Engineering Supplemental Instruction # 001

PROJECT: LFUCG FAYETTE COUNTY RECYCLING CENTER LIGHTING REPLACEMENT BID NO. 134-2018 360 Thompson Road Lexington, Kentucky 40508	OWNER: LEXINGTON-FAYETTE URBAN COUNTY GOVERNMENT 200 EAST MAIN STREET LEXINGTON, KENTUCKY 40507	CONSULTANT: SHROUT TATE WILSON CONSULTING ENGINEERS, PLLC 628 WINCHESTER ROAD LEXINGTON, KY 40505 859.277.8177 matthew.braun@stweng.com
---	--	--

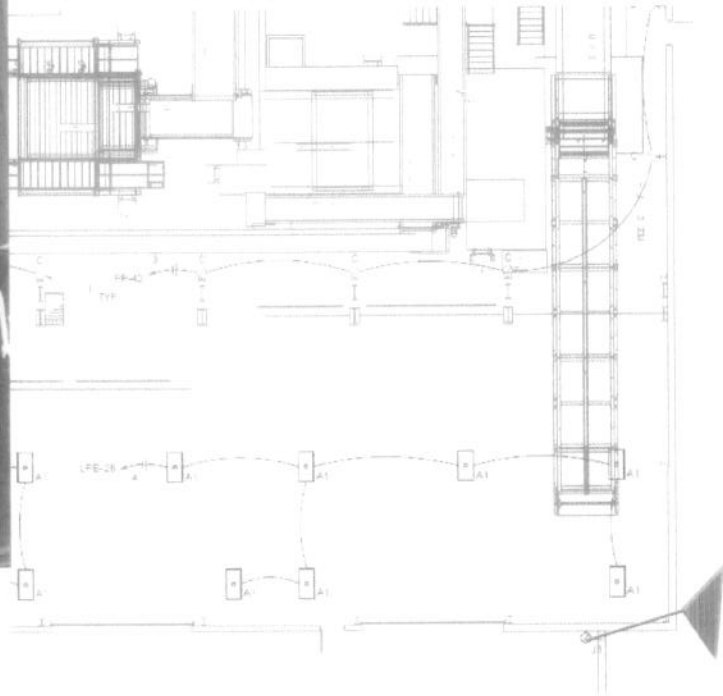
Flood light #2SouthEast Corner: Install owner provided Lumark Flood light fed off the same circuit as the adjacent Wallpack fixture power source. Flood to be aimed at the high traffic path below to increase safety and security. The owner provided fixture does not have a photocell control. The contractor will need to install a junction box and photocell in-line, so that the flood operated dusk to dawn. Contractor to provide all materials and labor.

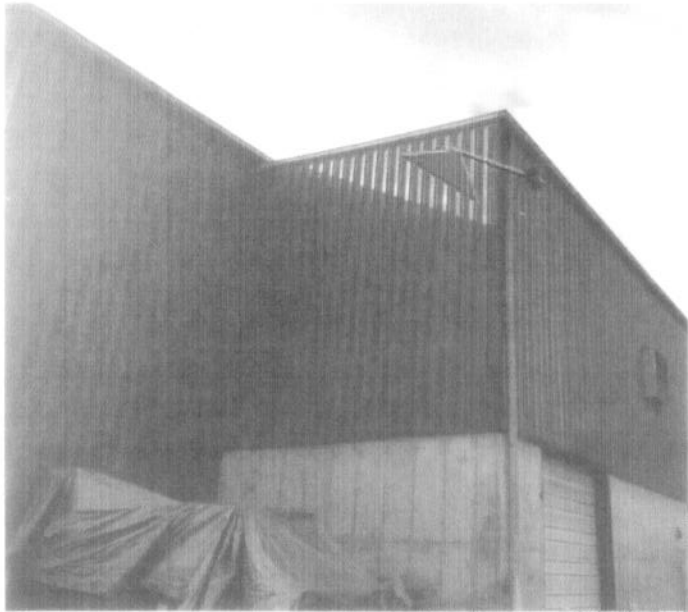
Flood light #1 NorthEast Corner: Install owner provided Lumark Flood light fed off the same circuit as the adjacent Wallpack fixture power source. Flood to be aimed at the high traffic corner below to increase safety and security. The owner provided fixture does not have a photocell control. The contractor will need to install a junction box and photocell in-line, so that the flood operated dusk to dawn. Contractor to provide all materials and labor.
